MEMORANDUM

To: Ms. Rebecca Chu, EPA
From: Ryan Barth, P.E., Anchor QEA, LLC
Amy Essig Desai, Farallon Consulting, LLC
Cc: Gil Leon, Earle M. Jorgensen Company
Miles Dyer, Jorgensen Forge Corporation
Bill Joyce and Ian Sutton, Joyce Ziker
Parkinson, PLLC
Jeff Kray, Marten Law
Chris Schraff, Porter Wright
Ravi Sanga, EPA
Holly Arrigoni, EPA
Maureen Sanchez, Ecology
Will Ernst, The Boeing Company
Tom Colligan, Floyd Snider
Philip Spadaro, The Intelligence Group
Re: Jorgensen Forge Early Action Area Removal Action
Addendum to the Final Basis of Design Report
Administrative Order on Consent, EPA Docket No. CERCLA 10-2013-0032

REVISED BODR FIGURES

Jan 23, 2014 6:30pm tgriga \\Galacal\Projects\0224-Farallon Consulting\Jorgensen Forge Facility EE-CA Implement\BODR\0224-BODR-Dredge Plan.dwg Figure 8a

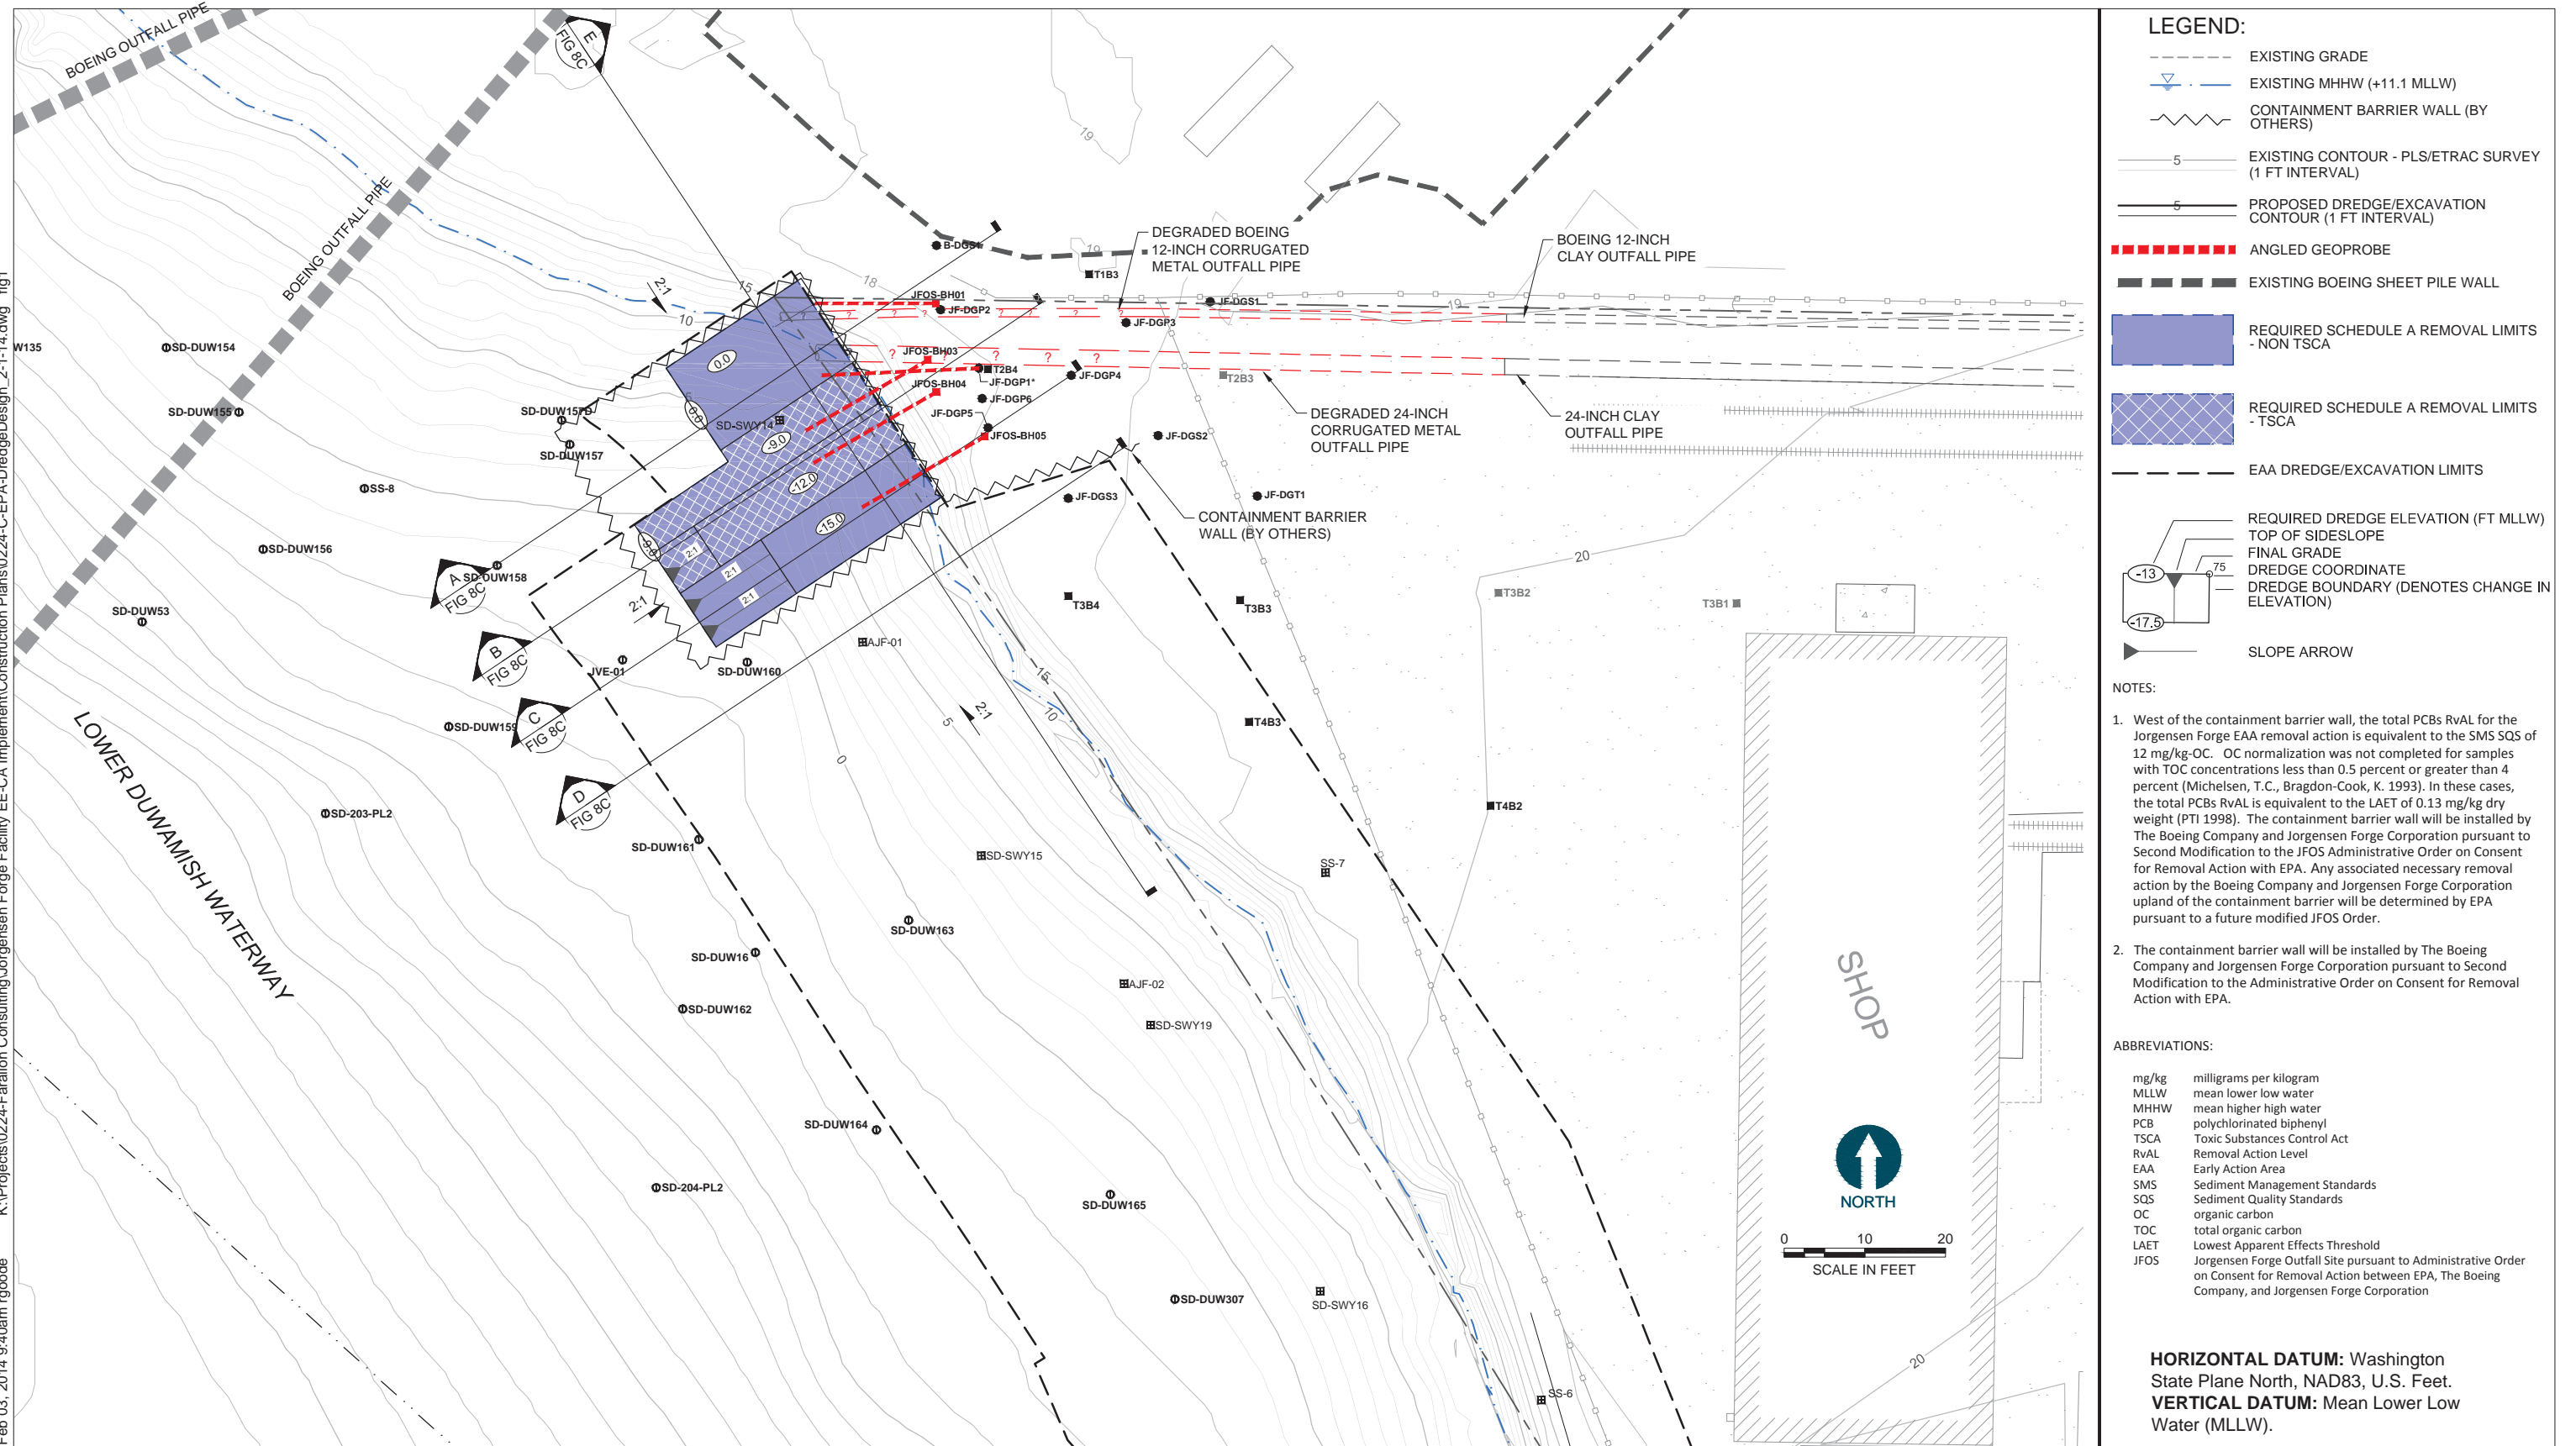
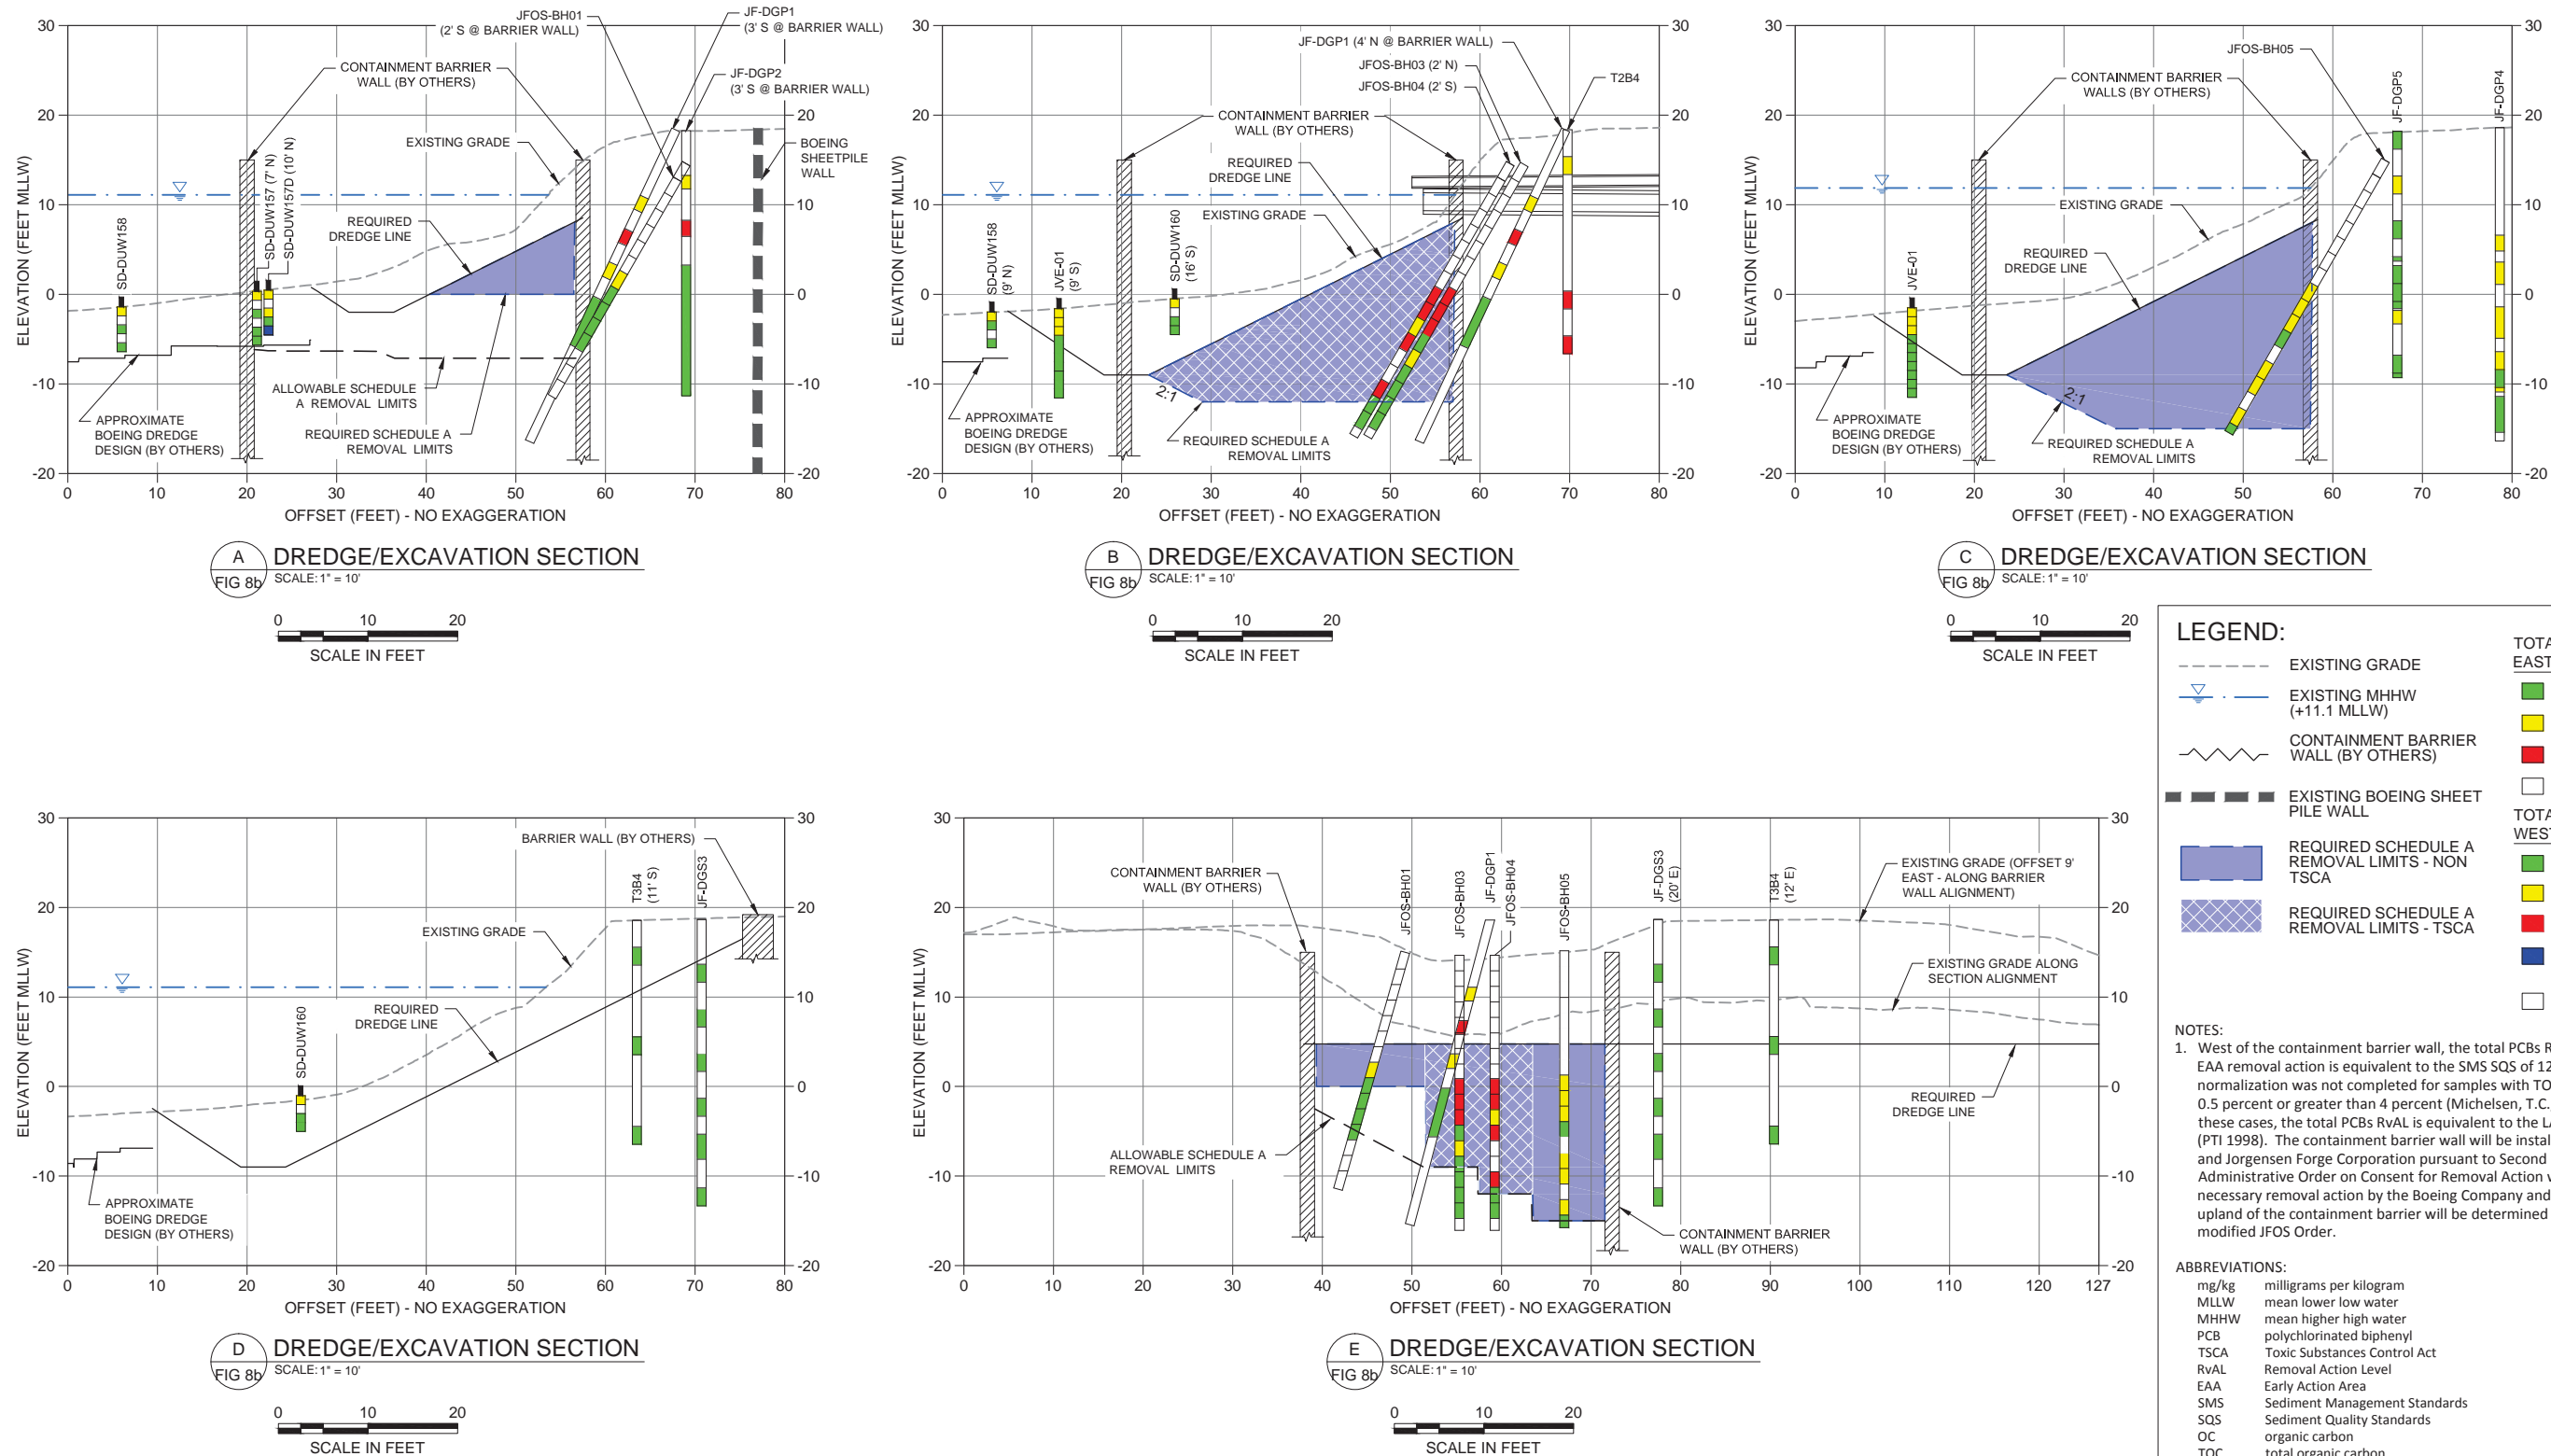
To maintain consistency with the removal action objectives presented in the BODR, Anchor QEA developed a revised dredge design within the northwest corner of the RAB to remove all sediment/soil total PCB concentrations greater than the RvAL. Anchor QEA submitted the revised dredge design drawings to EPA on December 19, 2013, which reflected the top-of-bank containment barrier wall alignment. The revised dredge design drawings submitted

to EPA on December 19, 2013 did not include the in-water containment barrier wall alignment. Figures 8a, 8b, and 8c in Attachment 1 show the revised dredge prism within the in-water containment barrier wall alignment. The EMJ Removal Action Construction Specifications have been revised to reflect the revised dredge design, revised contractor bids for removal within the in-water containment barrier have been received, and EMJ is currently finalizing contractor selection.
